TECHNICAL BULLETIN

RELOCATION OF AUTO REIGNITION CONTROLS AND MODIFICATION OF SYSTEM FOR FULL-TIME OPERATION

500 Model 369HE, 369HM and 369HS Series Helicopters equipped with PN 369H90118-505, -507, -509 and -511 Automatic Engine Reignition Kit.

Figure 1. Relocation of Auto Reignition Controls (Sheet 1 of 2)

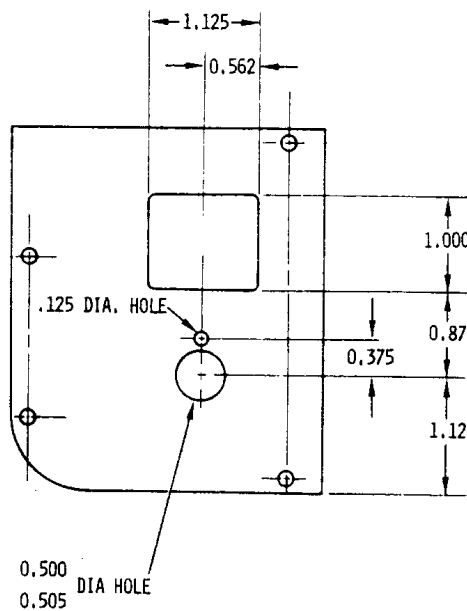
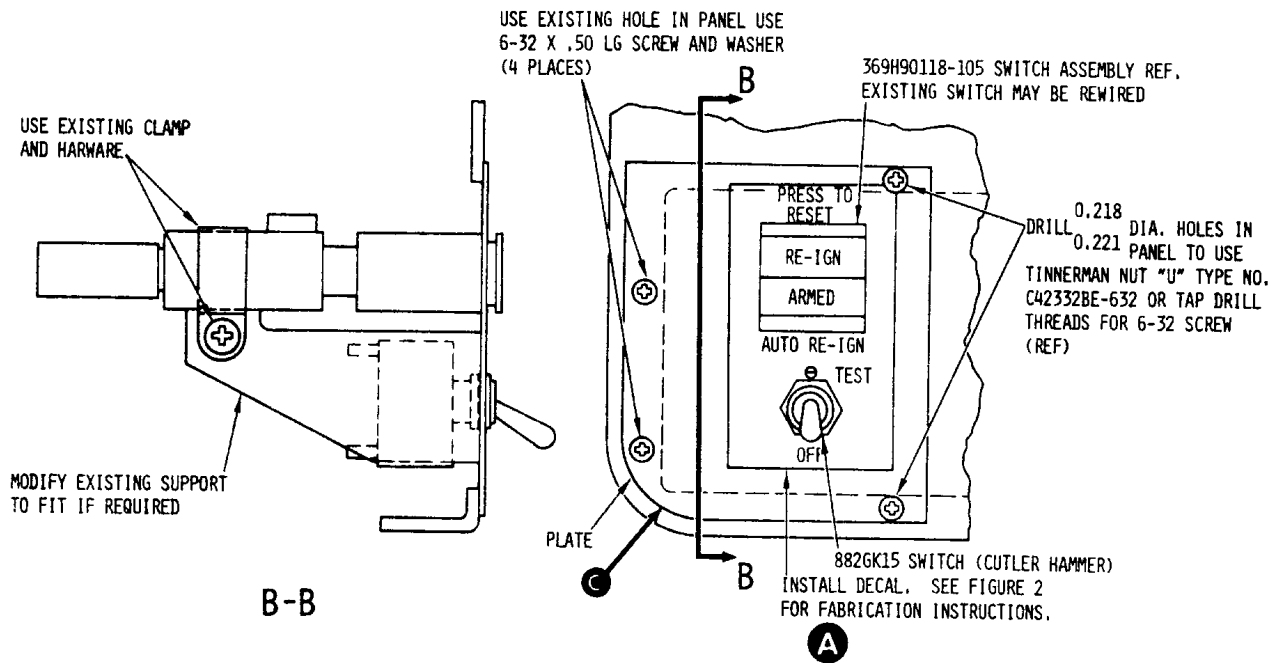
- (7). Install cover on instrument panel (see Figure 1).
- (8). Install plug button (369H6416 instrument panel only) (see Figure 1).
- (9). Paint out lettering at previous auto reignition switch location with acrylic lacquer (see Figure 1).

- (10). Fabricate plate, as required:
 - (a). Make plate from 0.062 inch thick aluminum alloy sheet as shown in Figure 1.
 - (b). Apply one coat HMS-15-1082 primer and dry for 1 to 2 hours.

- (c). Apply topcoat of HMS-15-1083 acrylic lacquer and air dry 4 hour minimum.
- (11). Install plate and auto reignition switch (XDS9) (retained above) and (S11) (PN 882GK15, Cutler Hammer or equivalent) at new location on instrument panel (see Figure 1).

Figure 2. Fabrication of Cover and Decal (Sheet 1 of 2)

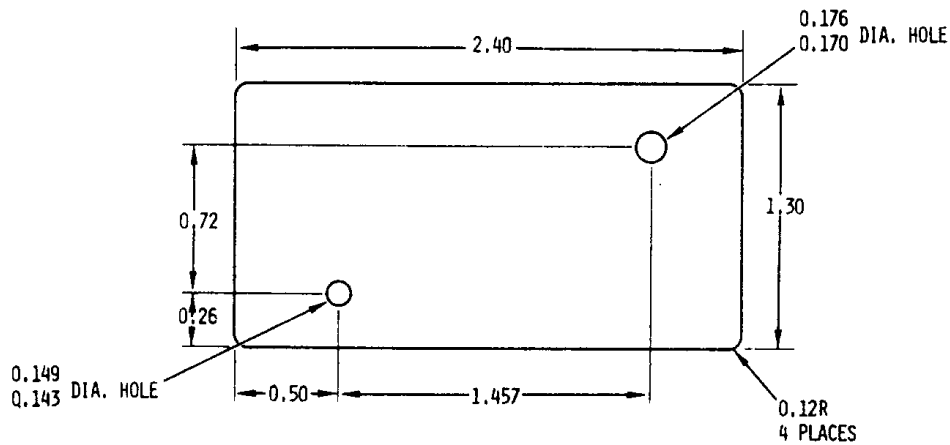
- (6). Fabricate cover, as required, for holes vacated by switches (see Figure 2).

- (12). Fabricate decal (see Figure 2).
- (13). Install decal (see Figure 1).
- (14). Revise wiring as follows (see Figure 3):
 - (a). Install diode at circuit breaker (CB101).

COVER
(FOR 369H6416 INSTRUMENT PANEL)
MAKE FROM ALUMINUM ALLOY SHEET, 2024-T3, QQ-A-250/5, TEMP T-3
0.03 X 1.062 X 1.187. APPLY ONE COAT HMS-15-1082 PRIMER AND DRY FOR
1 TO 2 HOURS. APPLY TOPCOAT HMS-15-1083 ACRYLIC LACQUER AND AIR
DRY 4 HOURS MINIMUM.

COVER
(FOR 369H90120 INSTRUMENT PANEL)
MAKE FROM ALUMINUM ALLOY SHEET, 2024-T3, QQ-A-250/5, TEMP T-3,
0.032 X 1.30 X 2.40. APPLY 3101-C10 BLACK NEXTEL SUEDE COATING PER
MANUFACTURER'S INSTRUCTIONS.

Figure 2. Fabrication of Cover and Decal (Sheet 2 of 2)

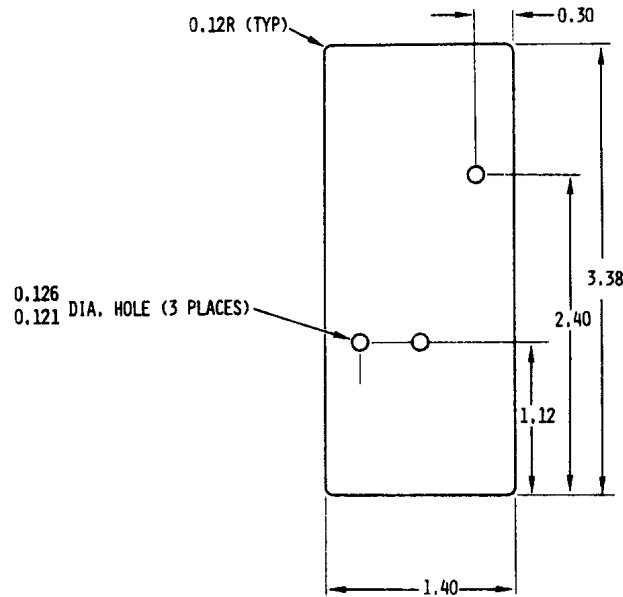
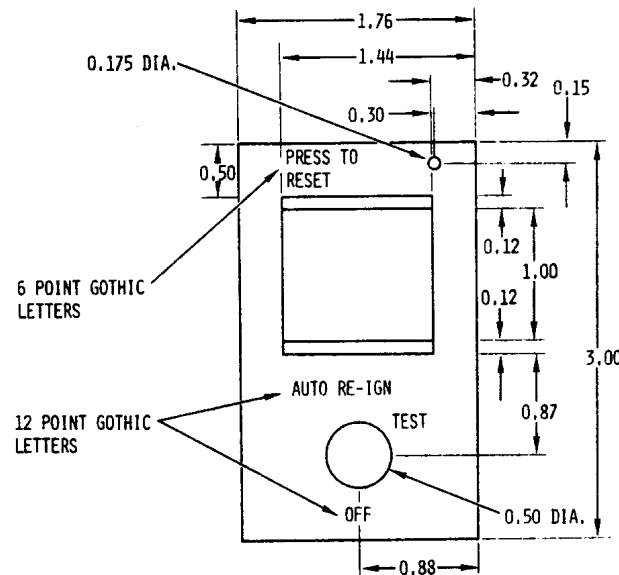
NOTE: It is not necessary to relocate the auto reignition indicator and switch installed in 369HM series helicopters. To complete the modification of 369HM auto reignition systems, replace switch S11 with PN 88ZGK15, Cutler Hammer or equivalent, spring loaded switch. Replace card switch to read OFF and TEST as shown in Figure 2. Continue modification with step (14).

MAKE FROM ALUMINUM ALLOY SHEET, 2024-T3, QQ-A-205/5, TEMP T-3,
0.032 X 1.40 X 3.38, APPLY 3101-C10 BLACK NEXTEL SUEDE COATING PER
MANUFACTURER'S INSTRUCTIONS.

MAKE FROM 3650 SCOTCH CAL BRAND FILM, BLACK BACKGROUND
(COLOR NO. 37078) WITH WHITE LETTERS (COLOR NO. 37875) PER
FED-STD-595

Figure 3. Wiring Diagram

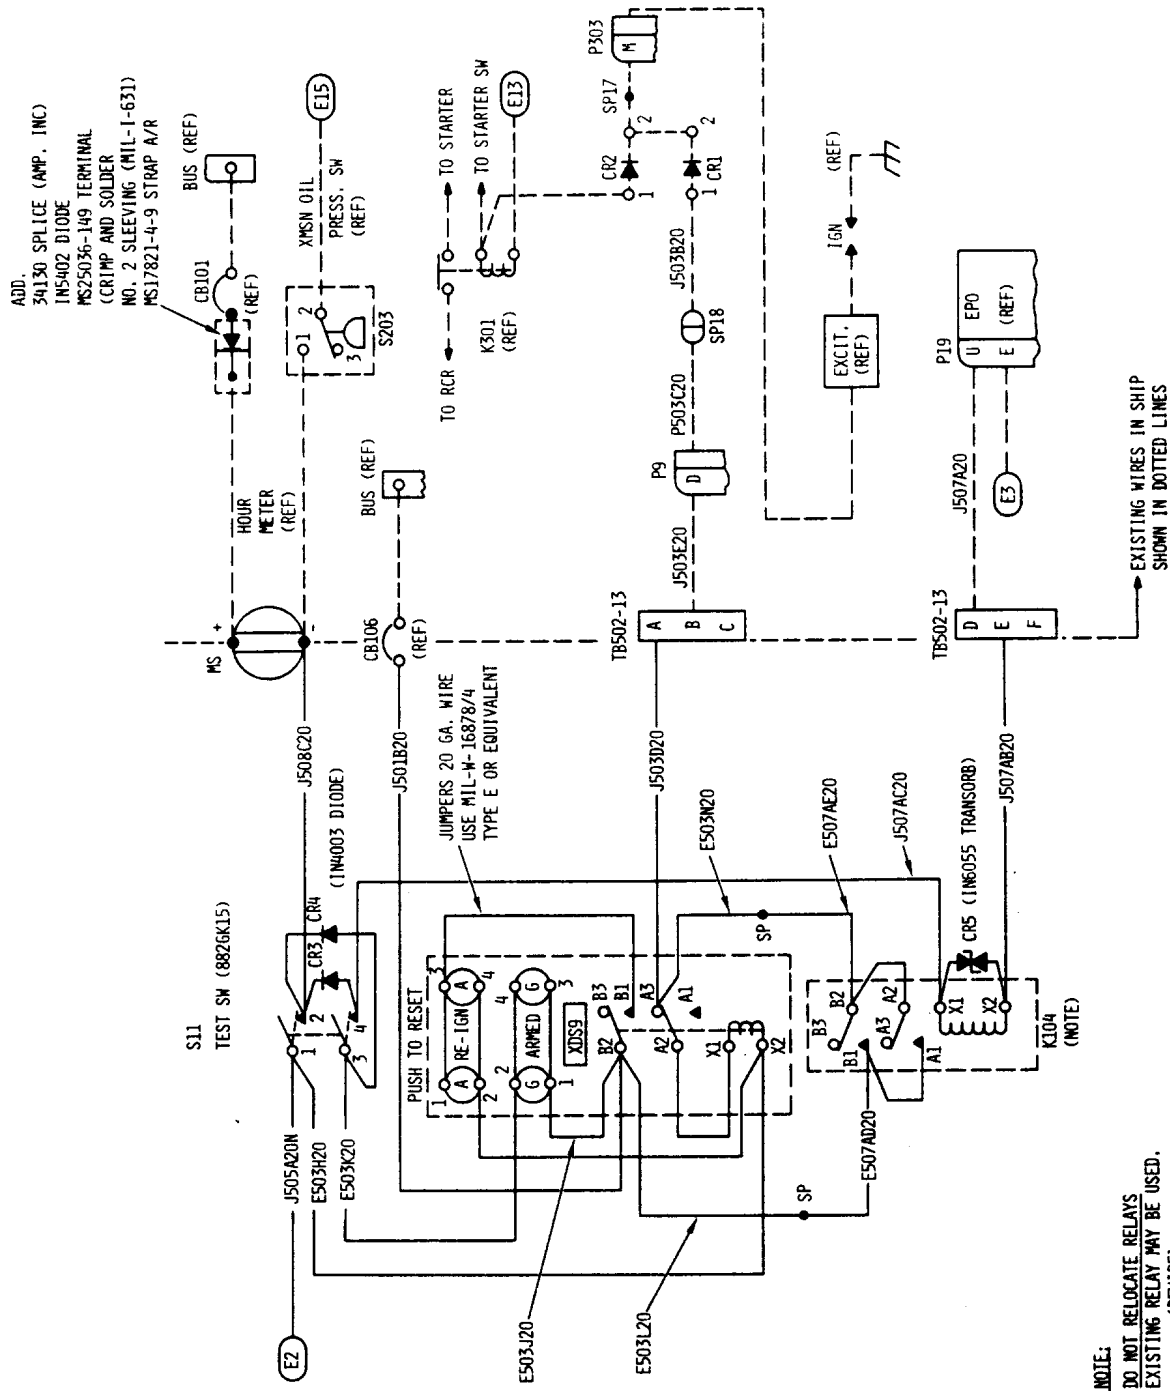
- (b). Install diodes (CR3 and CR4) on switch (S11).
 - (c). Install transorb (CRS) on relay (K104).
 - (d). Rewire switches (S11 and XDS9) and relay (K104) as shown.
